22 Feb 2024

ADDENDUM NO. 2

Re: **GS# 101-328**
Dormitory Renovations (Re-Bid)
Alcorn State University
Lorman, Mississippi

L. Plaster Patching:

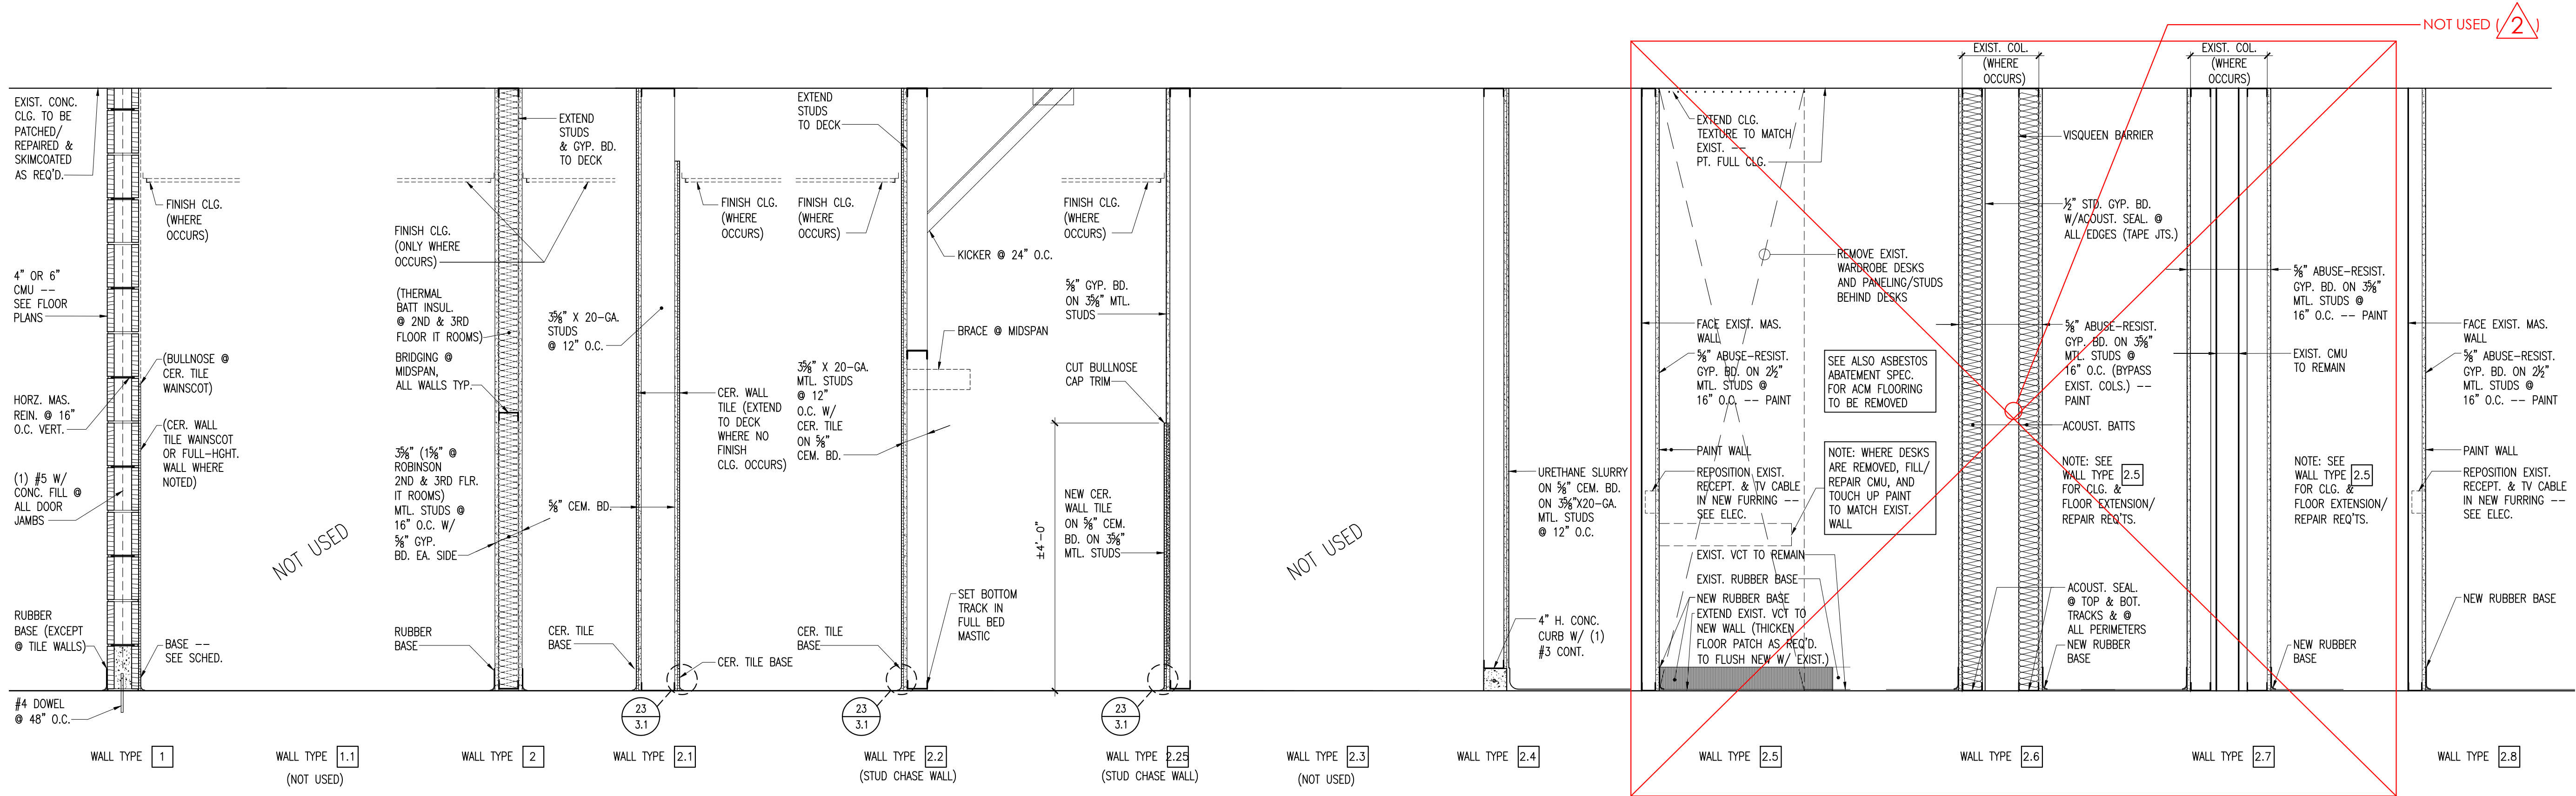
- Item No. 5:** Refer to Specifications and add new Section 09 21 00 – Lath and Plaster (Exhibit "C"), for use in patching of existing plaster ceilings and soffits.

1. Upon completion, point-up and patch both new plaster and existing plaster to remain. Cut out and patch defective and damaged plaster. Patching of plaster shall match existing work in texture and finish and, at joining with existing or previously applied plaster, shall finish flush and smooth.

Typ. Window Head Detail at Windows "C"

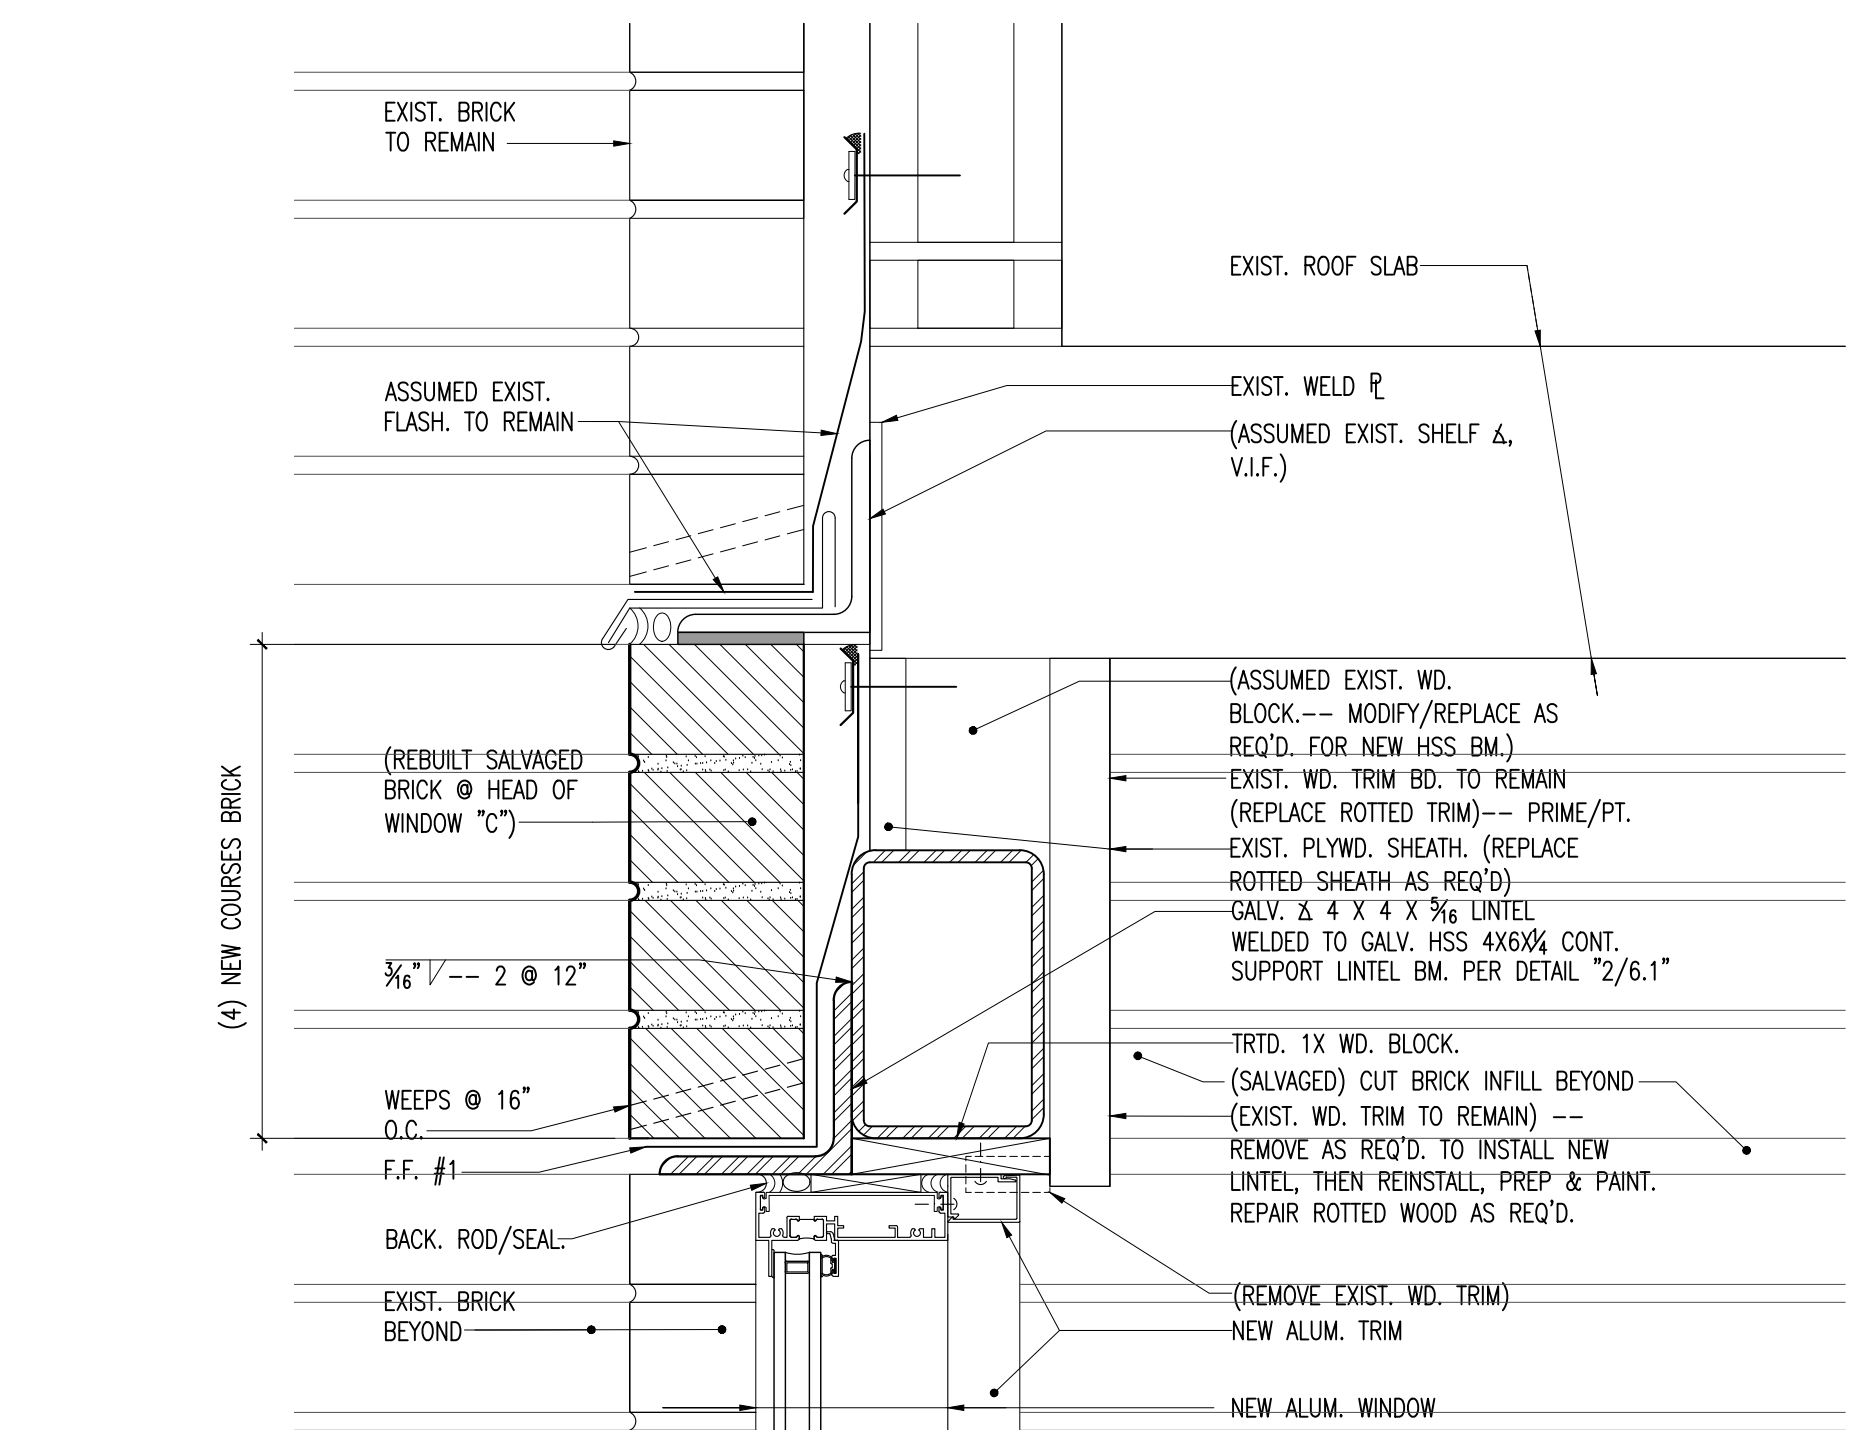
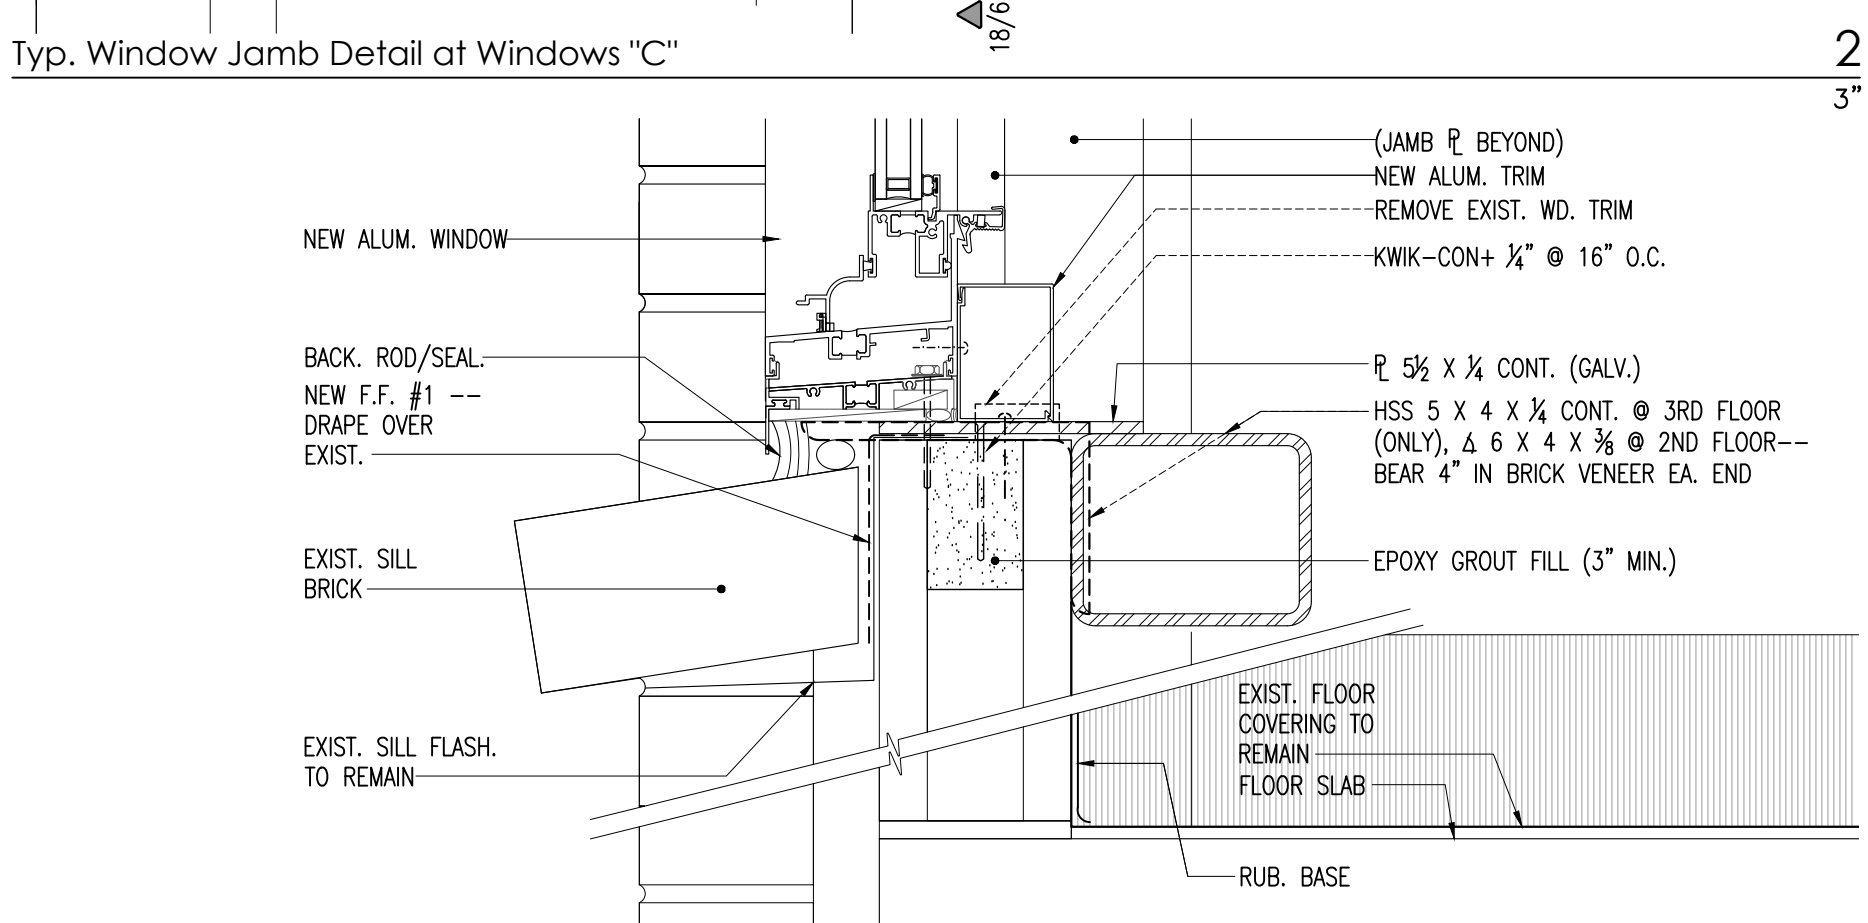
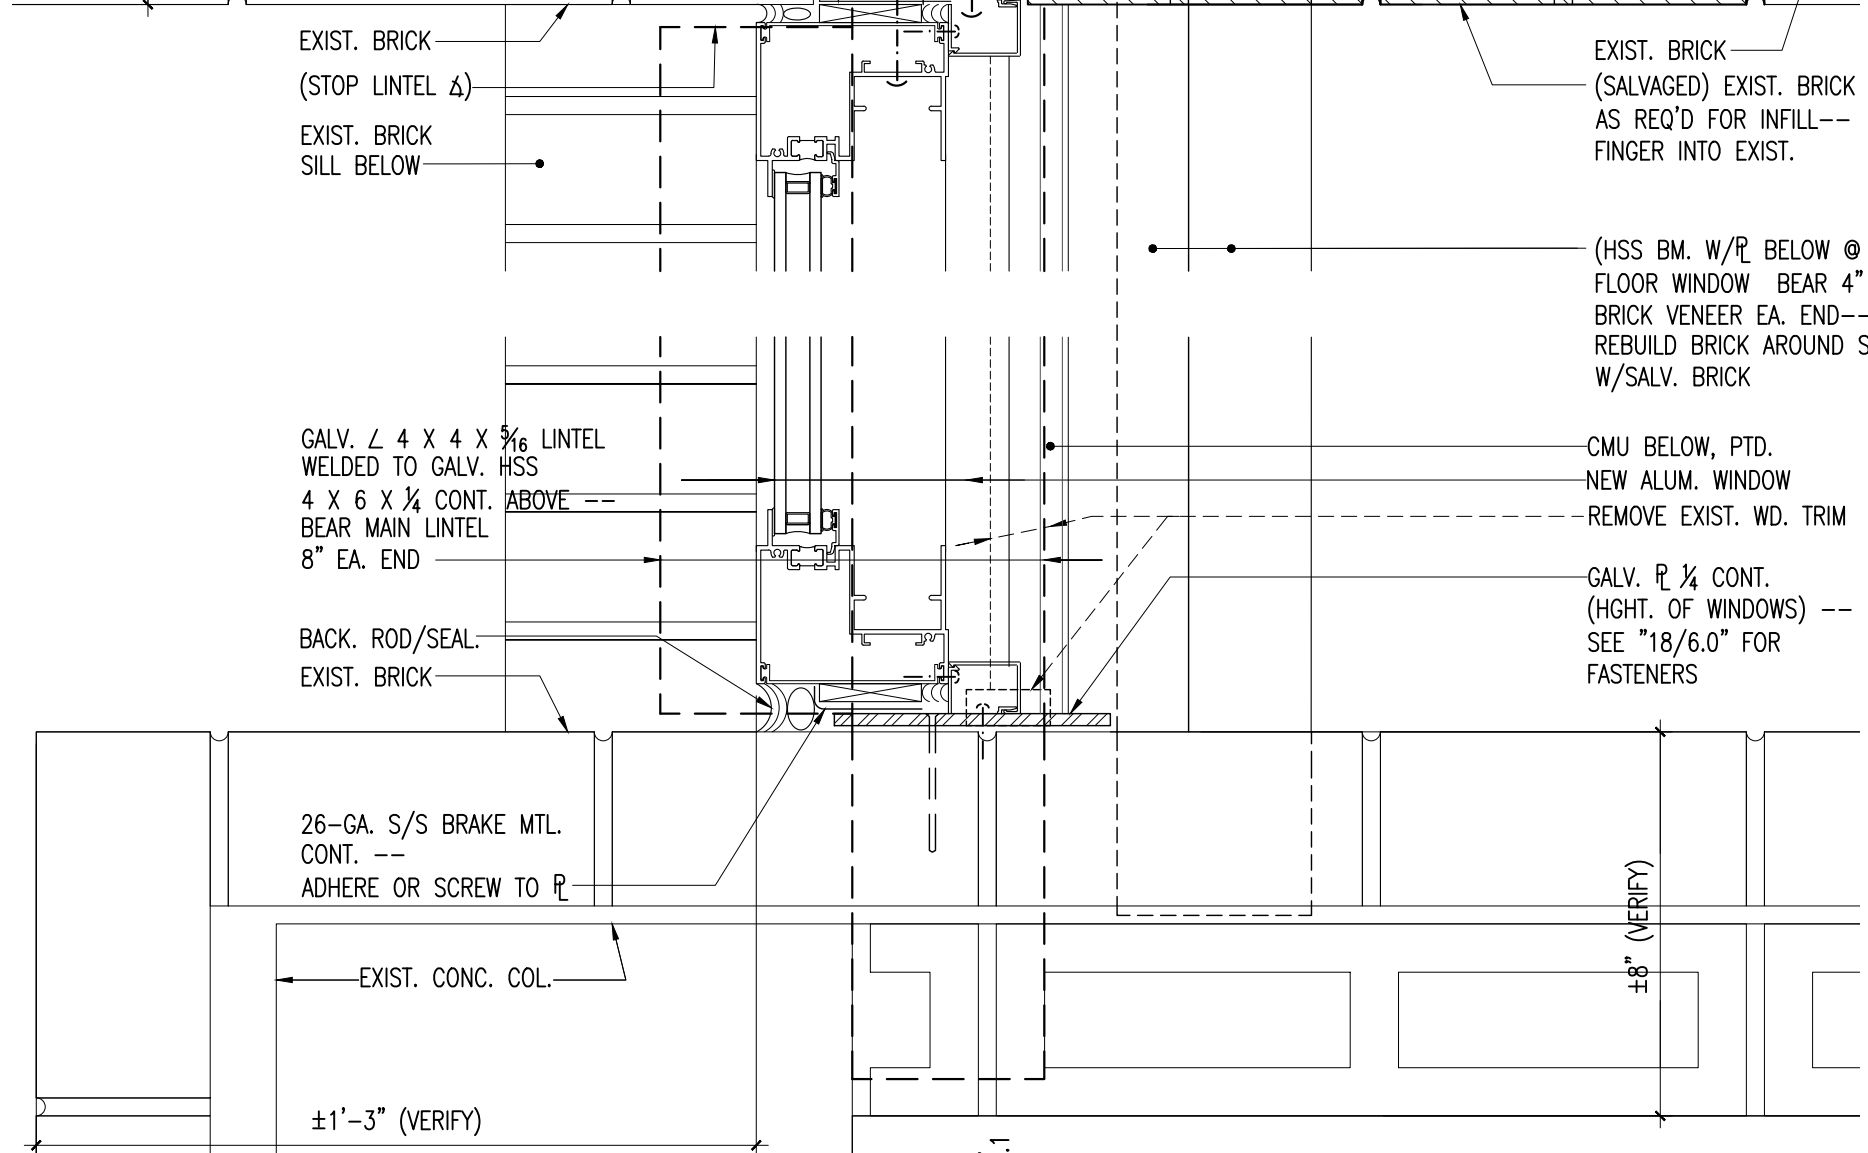
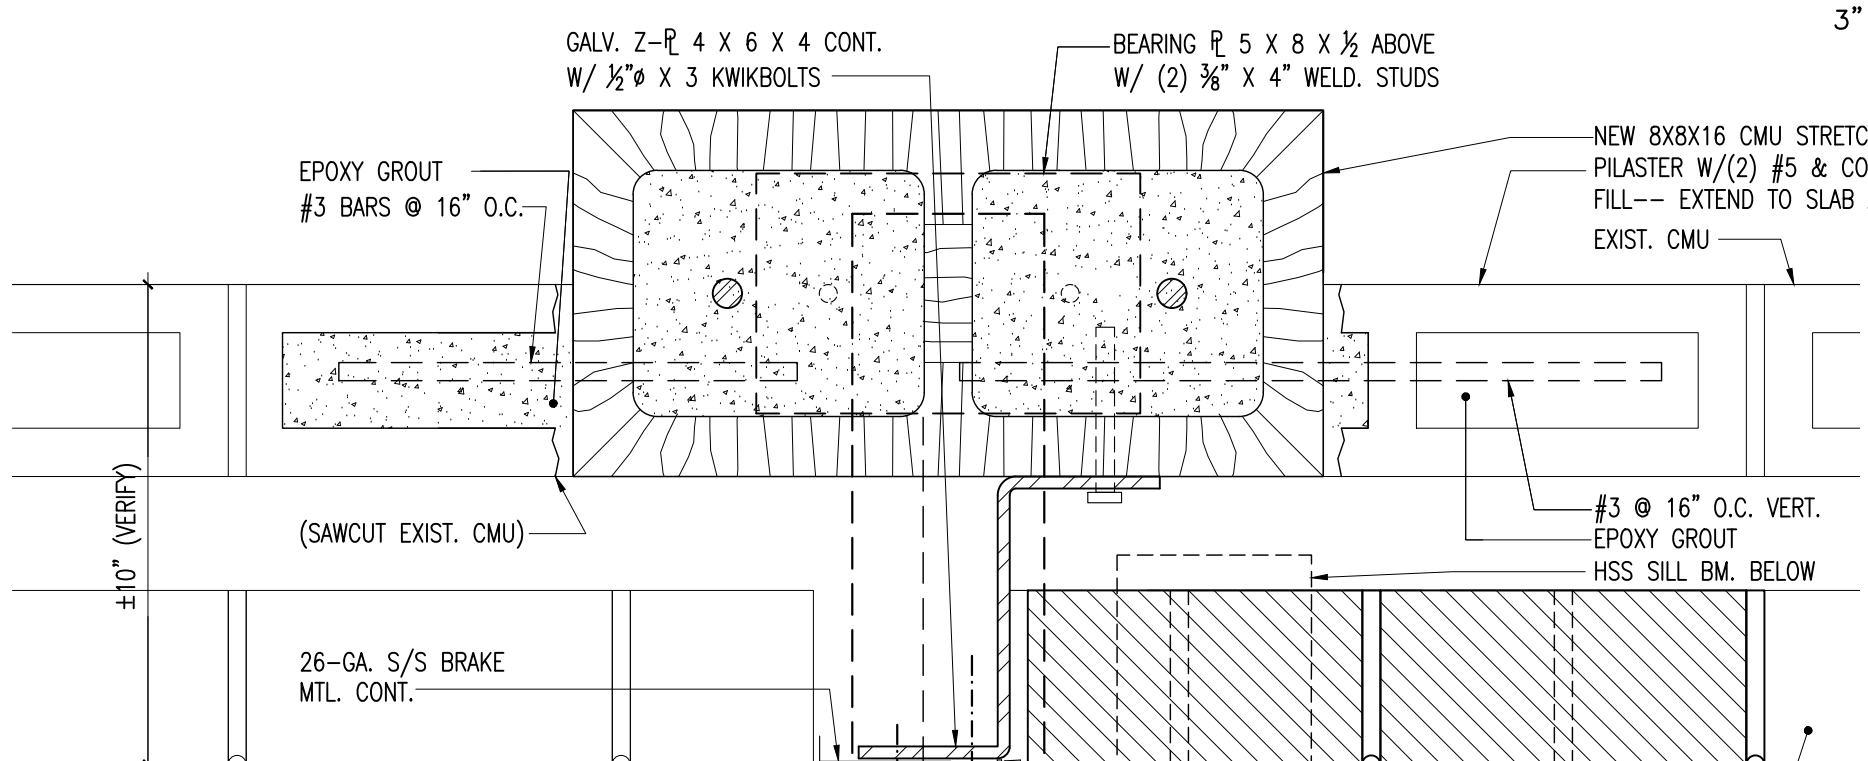
- Item No. 1:** Refer to architectural drawings and replace Sheets TS, 0.5, 2.0, 4.0, and 6.0 with the new annotated sheets attached hereto (Exhibit "D").
- Item No. 2:** Refer to Sheet 4.0, details 10A and 10B, and clarify that the end-dams required in these details do not occur at window lintels—this note refers to the continuous metal thru-wall flashing that occurs on the continuous shelf angles. End-dams would occur only at the end of a run, such as where a run of flashing terminates into a wall (e.g., at Window "C").
